STATE OF NORTH CAROLINA
DEPARTMENT OF TRANSPORTATION

SUBJECT: **Request for Modification of the Section 404 Individual Permit, Section 401 Water Quality Certification, Isolated Waters State General Permit, and Neuse River Riparian Buffer Certification** for the proposed East End Connector from NC 147 (Durham Freeway/Buck Dean Expressway) to north of NC 98 (Holloway Street) in Durham, Durham County, North Carolina, Division 5. Federal Aid Project No. NHF-76-1(2), TIP No. U-0071.

The purpose of this letter is to request a modification to the United States Army Corps of Engineers (USACE) Section 404 Individual Permit and North Carolina Division of Water Resources (NCDWR) Section 401 Water Quality Certification, Isolated Waters State General Permit, and Neuse River Riparian Buffer Certification for the above-referenced project.

In addition to this cover letter, please find enclosed revised Wetland Permit Drawing Sheet Nos. 20, 21, 43, 44, 75, 90, and 91 of 91; revised Buffer Permit Drawing Sheet Nos. 5, 9, 10, 17, and 18 of 18; and the revised Mitigation Acceptance Letter from the N.C. Division of Mitigation Services (DMS).

Wetland and Stream
Permit Drawing
75 of 91

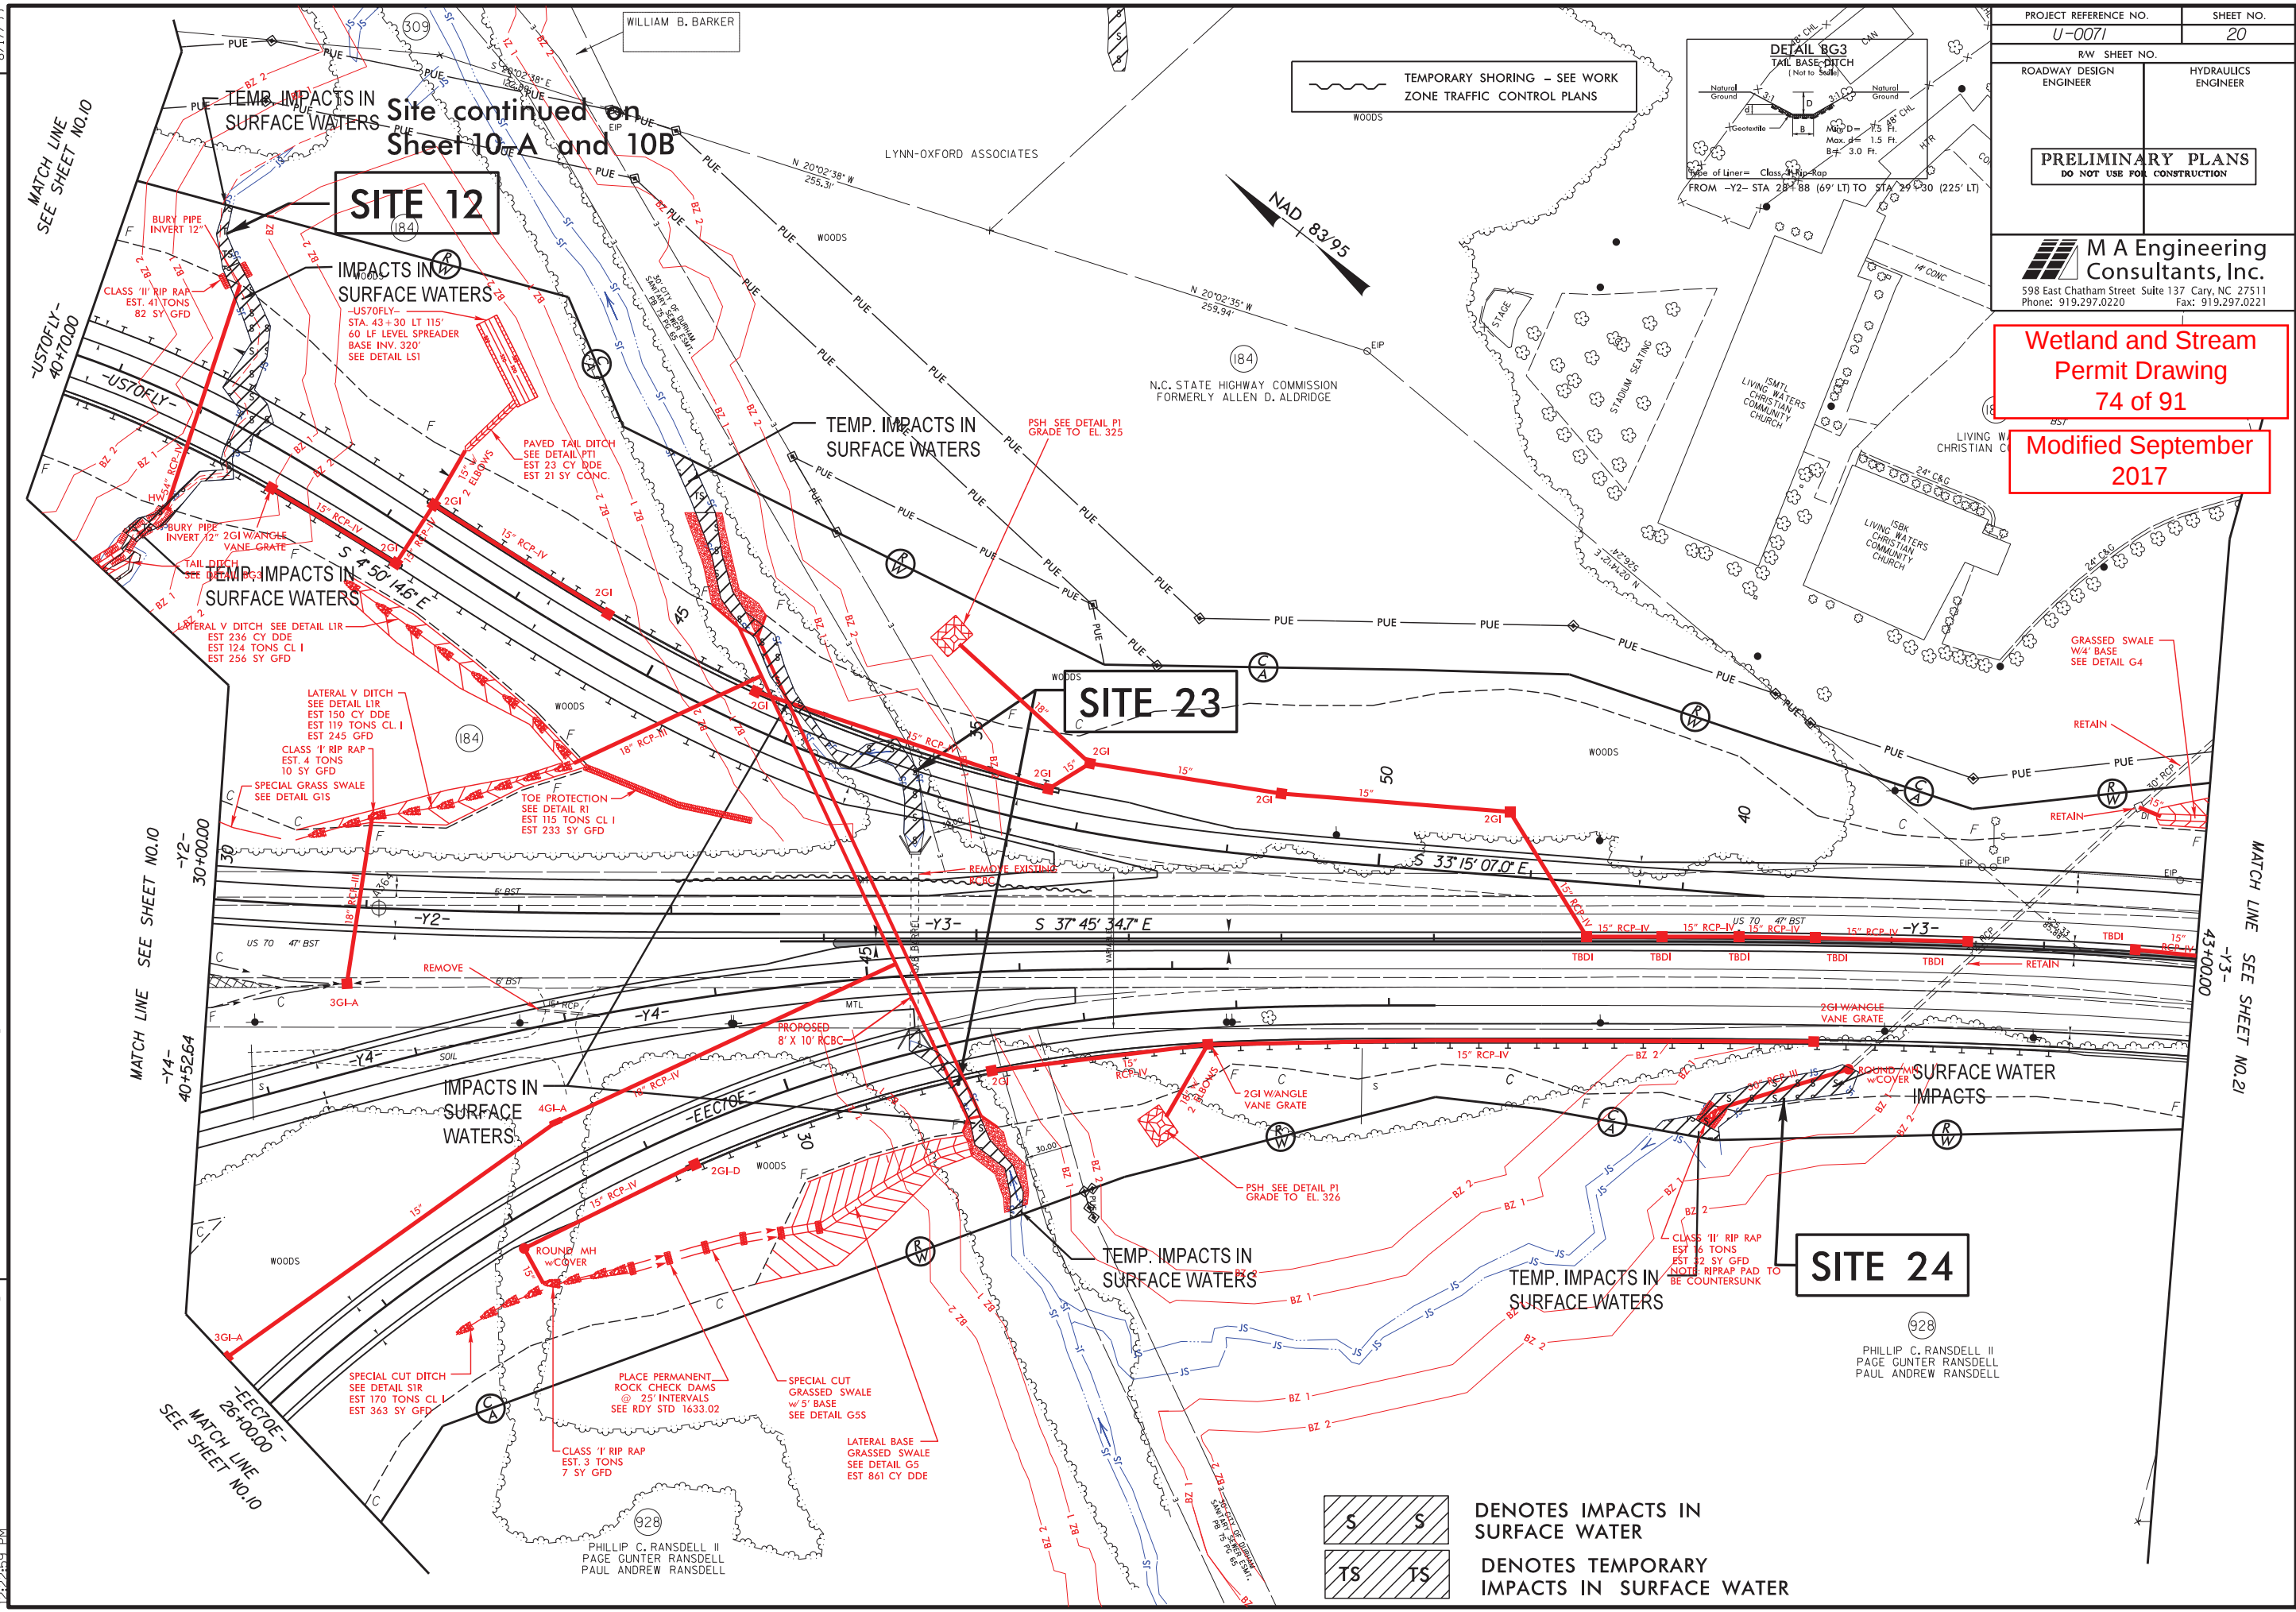
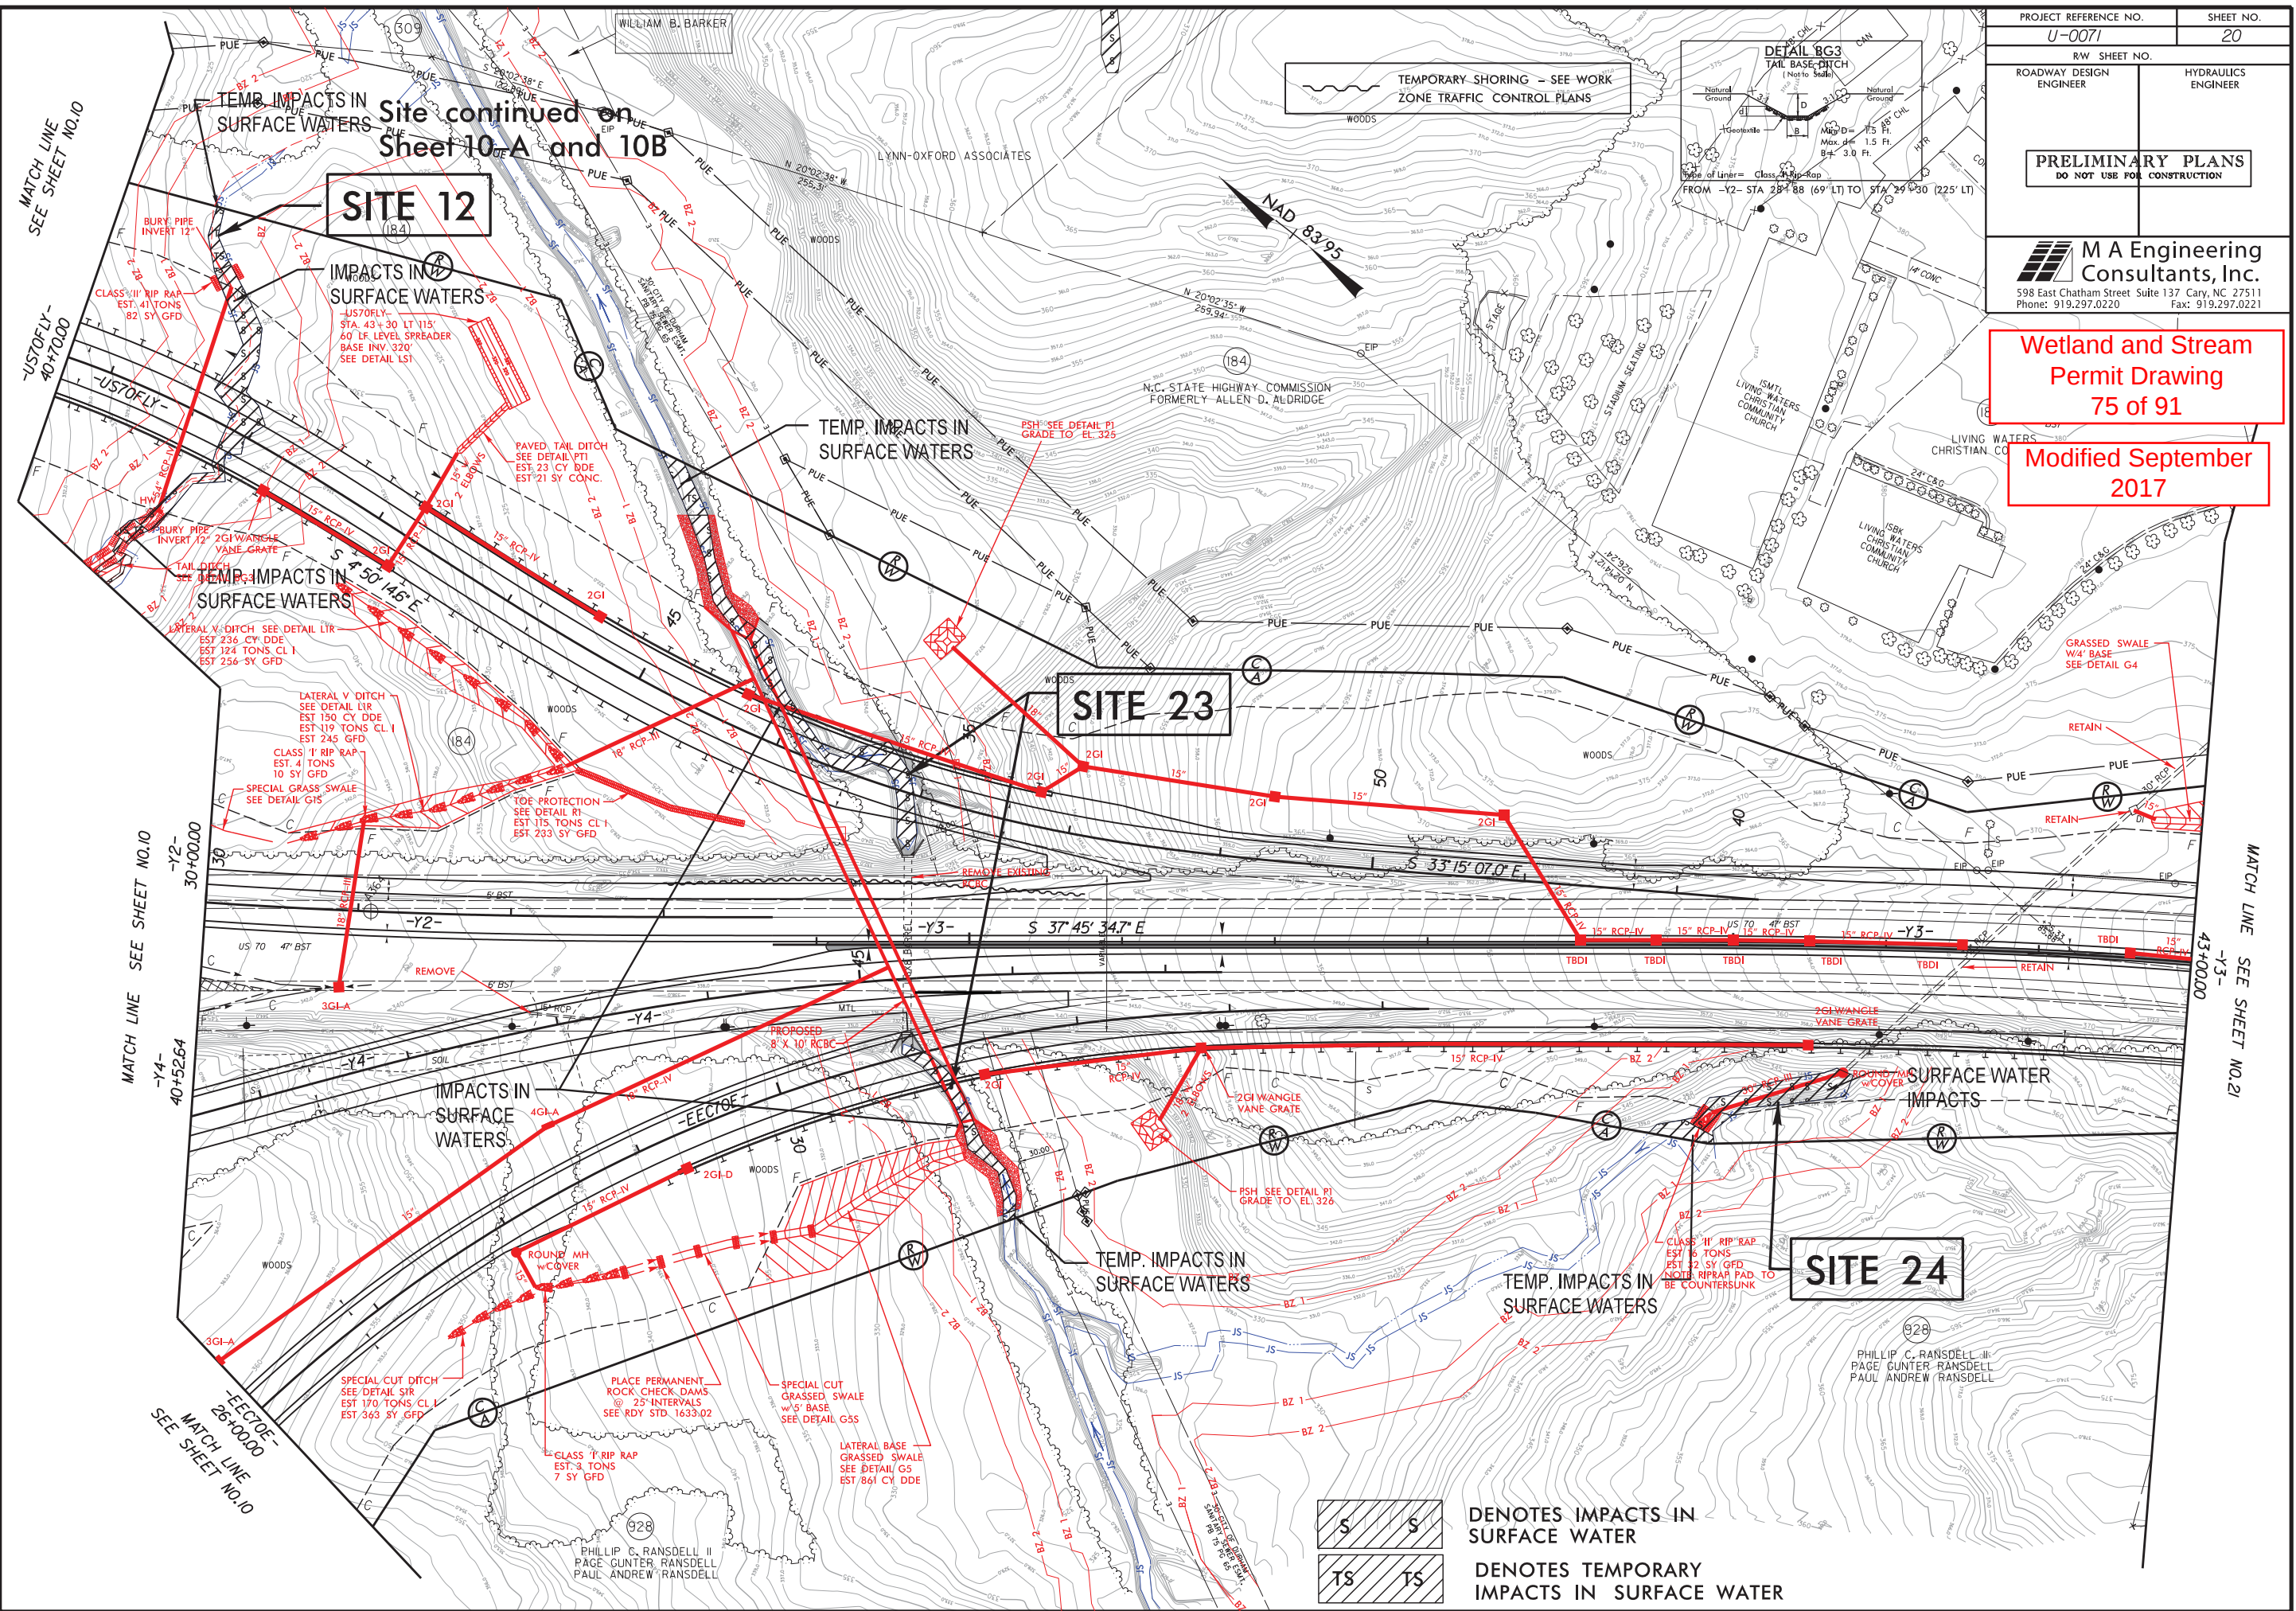
All revisions occur within the Neuse River Basin (HUC 03020201). Stream impact revisions occur at Site 23. A review of the Erosion Control diversion plan indicates that the tie-in point for the diversion channel at this site is upstream of the previously-depicted rip rap on the streambank. The Division asked the culvert subcontractor to see if they can tighten the diversion channel to fall within the previously-depicted and permitted rip rap bank stabilization. The subcontractor indicated that the topography and grade changes at the site will not allow them to bring in the diversion tie-in point any closer to the culvert. Therefore, additional Class II rip rap bank stabilization is proposed to cover the tie-in point and the opposite bank, since there are concerns that the soil at this location is poor and there is no way to backfill, seed, and matt the area to create an effective stable streambank. Please see Table 1, which has been revised to reflect these modifications. Revised Sites, sub-totals, and totals are in bold.

The only changes to wetland impacts occurs in the Neuse River Basin (HUC 03020201). At Site 10, 0.03 acre of mechanized clearing was added to Wetland W-25. Site 11, which was formerly <0.01 acres of mechanized clearing to Wetland W-24, has been removed as an impact.
